Title		
CLOCK CONTROLLER PCB SCHEMATIC		
Size	Number	Revision
B		
Date:	1-May-2001	Sheet 2 of 4
File:	E:\PROBERTS\...CLKDIV2.SCH	Drawn By: PAUL ROBERTS

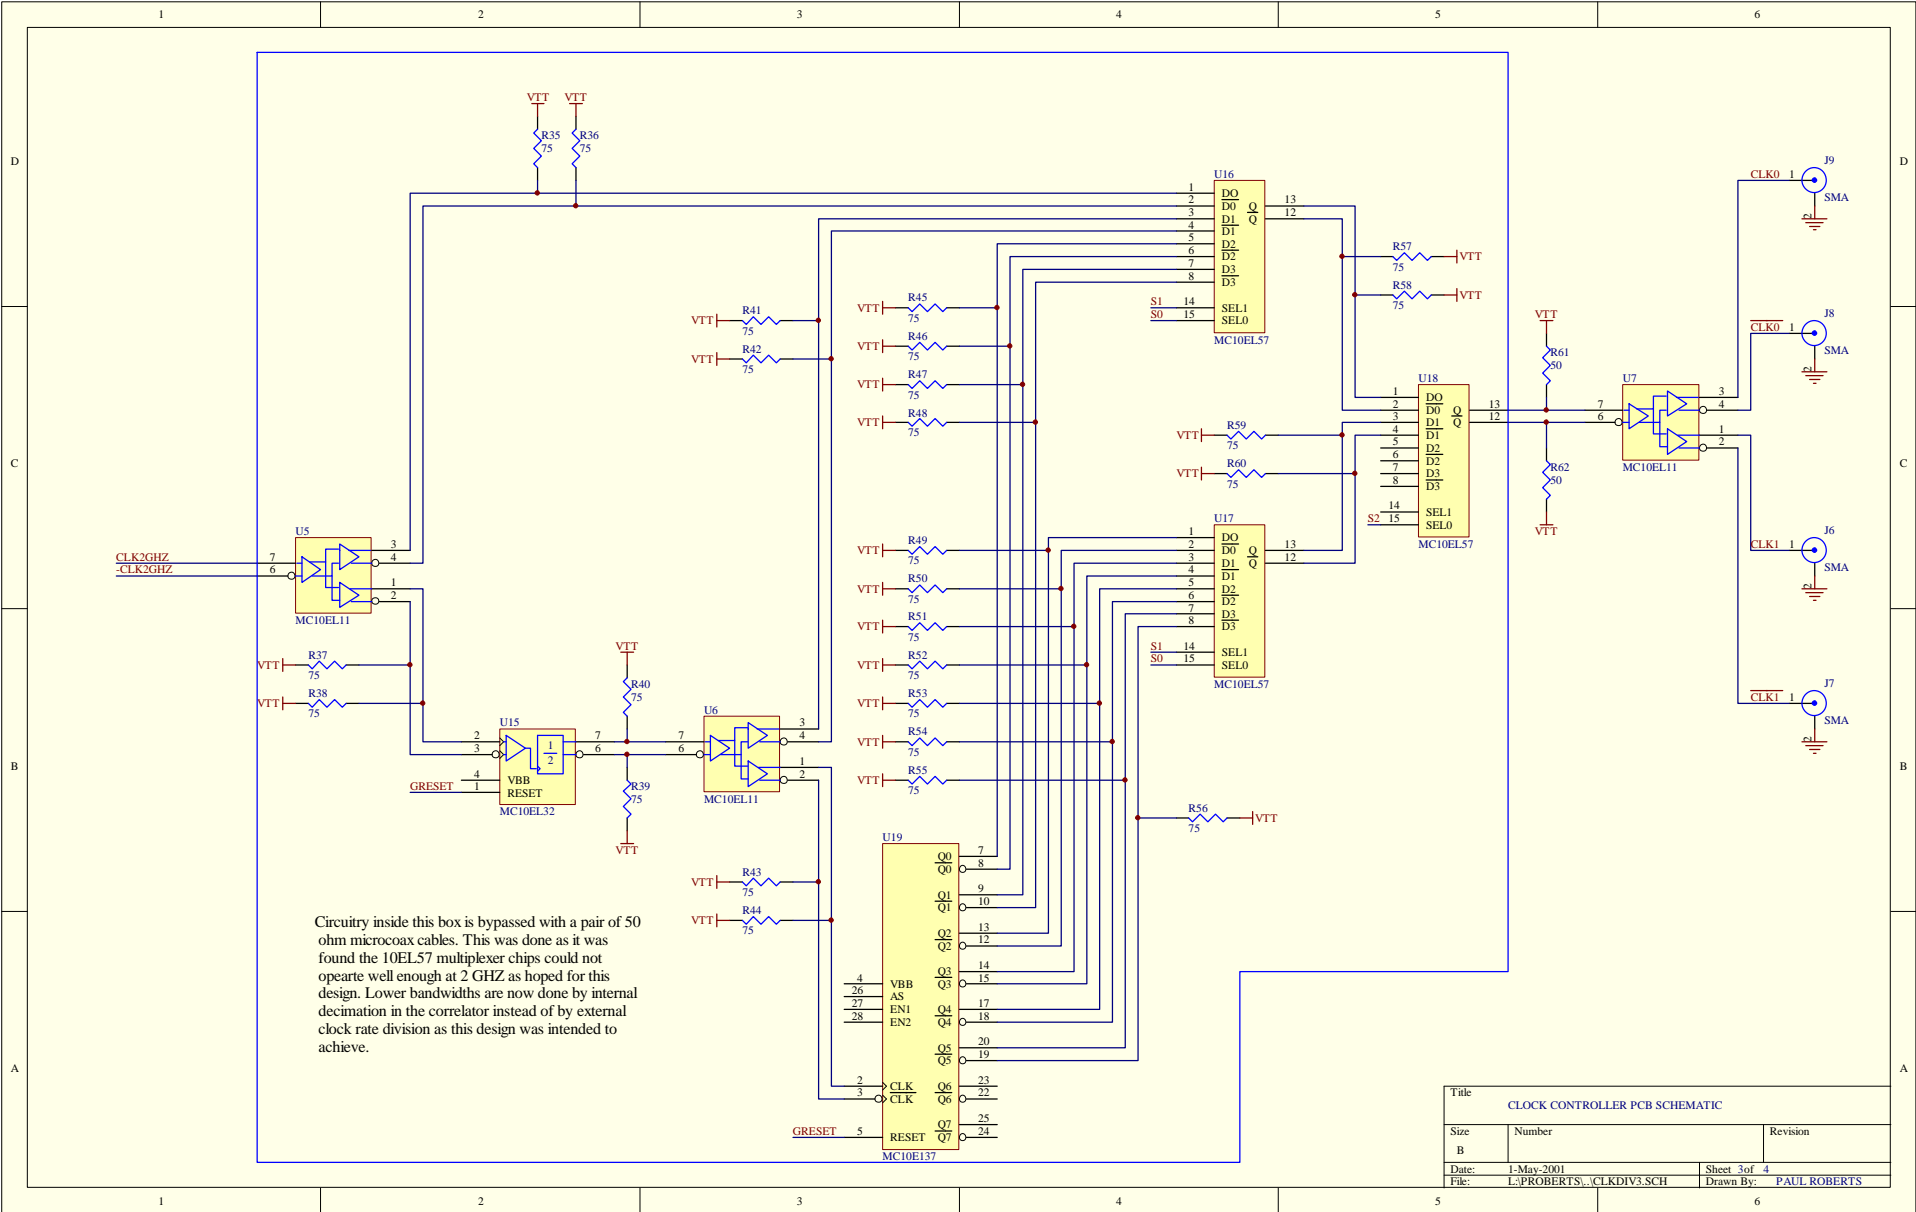
Circuitry inside this box is bypassed with a pair of 50 ohm microcoax cables. This was done as it was found the 10EL57 multiplexer chips could not operate well enough at 2 GHz as hoped for this design. Lower bandwidths are now done by internal decimation in the correlator instead of by external clock rate division as this design was intended to achieve.
